MFN 08-277, Supplement 1

Subject: **Transmittal of LTR NEDO-33411, "Risk Significance of Structures, Systems and Components for the Design Phase of the ESBWR," Revision 1**

**Licensing Topical Report
NEDO-33411**

**Change List
NEDO-33411 Revision 1 Changes**

Figure 1 – Process for Identifying Risk Significant SSCs

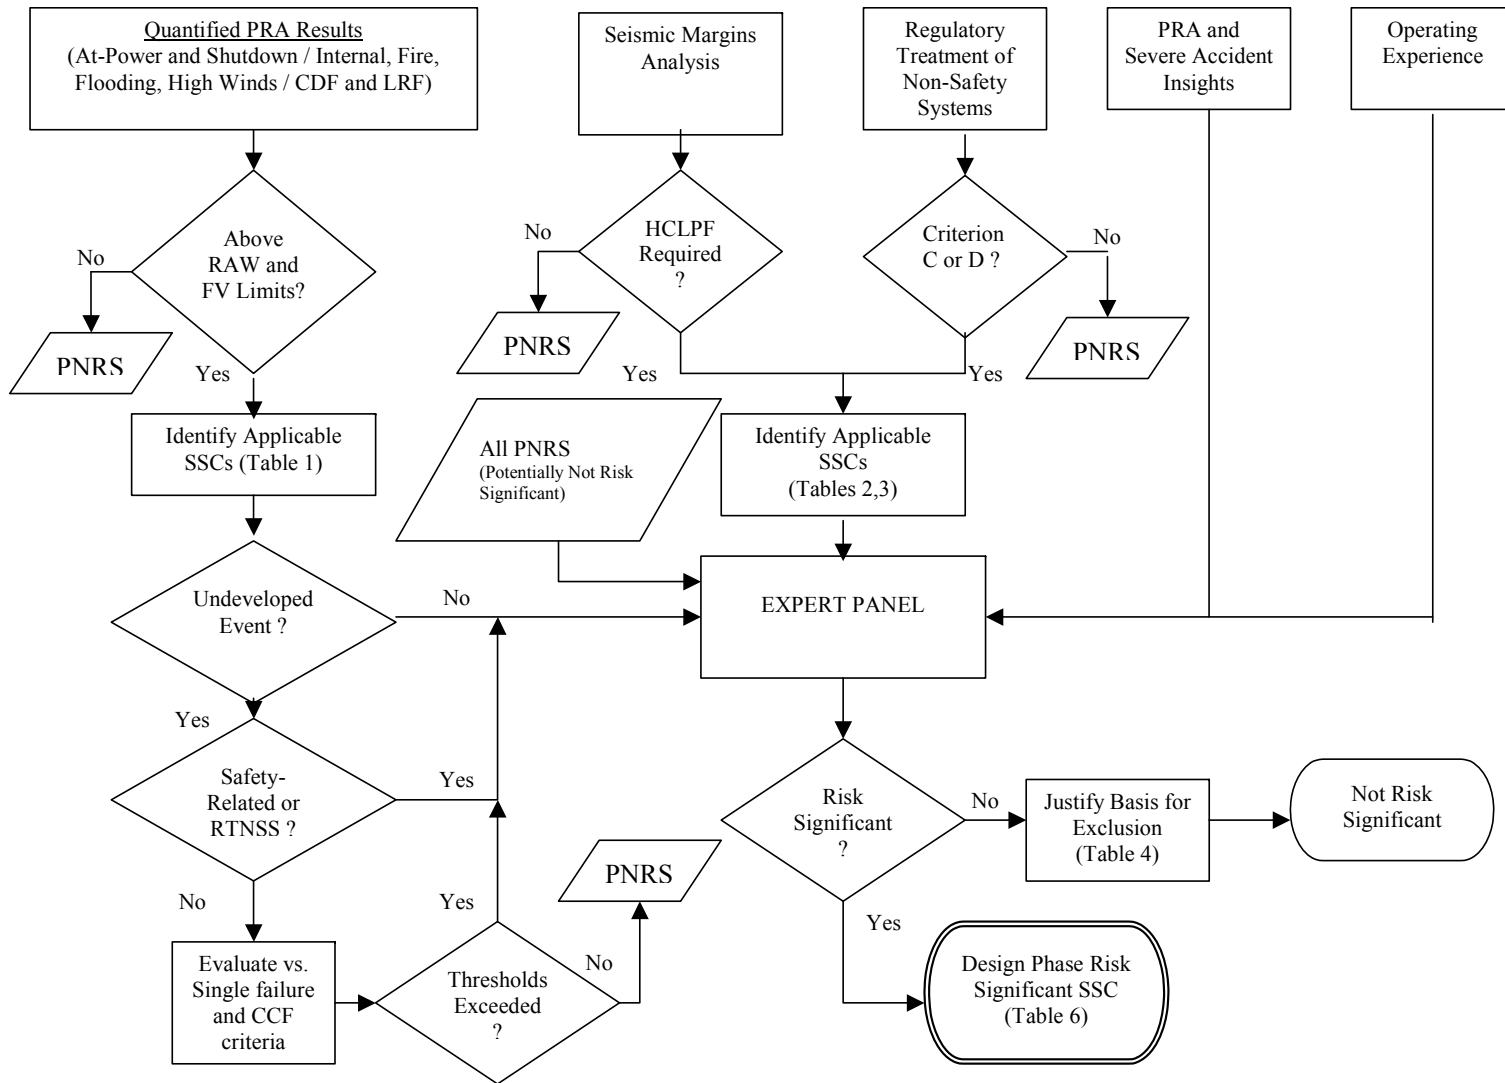
8.	S 2.6 para 1	Deleted specific information for the Revision 0 expert panel.
9.	S 2.6 para 2	Added for clarification in response to RAI 17.4-20 S01.
10	S 3.1.1 para 5	Deleted specific information from the Revision 0 expert panel that has changed. Locked open manual valves have position indications and are also addressed in human factors engineering. Main control room displays are added as risk-significant per the request of RAI 17.4-4 S01.
11	S 5.0	Updated to NEDO-33210 Revision 4.
12	T 1	Completely updated based on NEDO-33210 Revision 4.
13	T 2	Updated based on information in DCD Table 19.2-4.
14	T 3	Updated Title for clarification and revised table information based on DCD Table 19A-2.
15	T 4	Table 4 is derived from Table 1 and has been completely updated.
16	T 5	Deleted. This panel was specific to Revision 0.
17	T 6	Updated to include new results from Tables 1, 2, 3 and 4.
18	F 1	Updated for clarification in response to RAI 17.4-24 and

GEH revised the portion of Figure 1 to clarify the evaluation of undeveloped events.
